# Code Technology Committee

## Area of Study – Climbable Guards

### 2009/2012 Cycle

#### Code changes related to the CTC area of study noted above

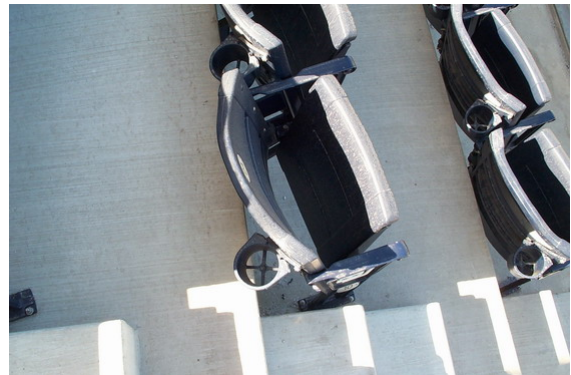
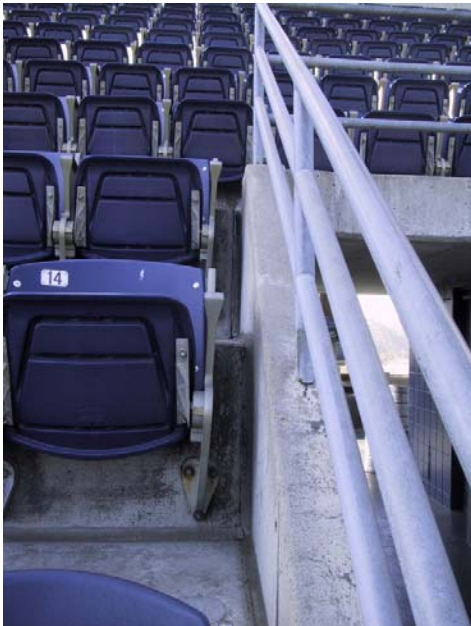
Following are two photographs of self-rising chairs and one of bench seats. The fixed bench seating could serve as a walking surface, however the self-rising chairs are not easily used as a walking surface. 2007 ICC 300 measures vertically above the leading edge of the tread, adjacent walking surface or adjacent bench seat. This proposal maintains how the height of the guard is measured by 1013.2 with the exception of replacing the term "fixed seat" with the term "bench seat" to coordinate with ICC 300 and to enhance clarity that guard height needs to be measured vertically above such seats. Also, the term "bench seat" rather than "seatboard" is commonly used for this type of seating in assembly seating project specifications. An exception was added for self-rising chairs since these seats are not easily used as a walking surface and there is no well defined way to measure these chairs.

**Exception:** The height of the guard shall not be required to be measured vertically above an adjacent automatic or self-rising chair.
